# Access Compliance Report

## Public Rights-of-Way

### (Pedestrian Signals)

Intersection ID: N/A	Main Street:	Cross Street: N/A	Location: N/A
ADA ID: AE328F9CC52A	Signal Type: One Push Button-Non APS	Overall Compliance: No	Severity Score: BTN 1: N/A BTN 2: N/A No BTN: N/A
Codes/Mitigation Info/Possible Solution		Field Measurements/Component Compliance

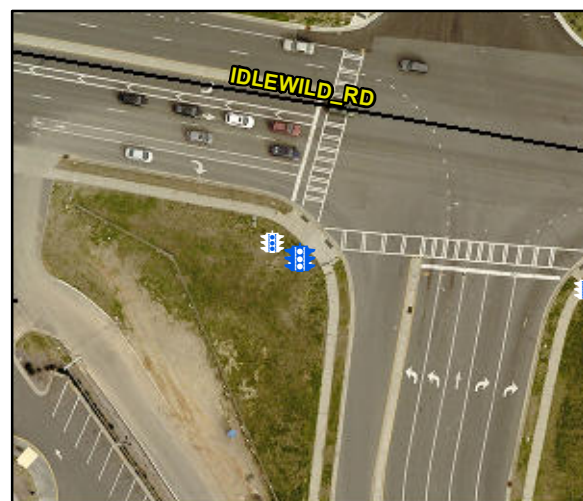
PROW/ADA: TMUTCD 4e.08, R404.2, R406.2

Possible Solutions: Replace Signal Push Button With APS Button on New Post. Remove & Relocate Sign.
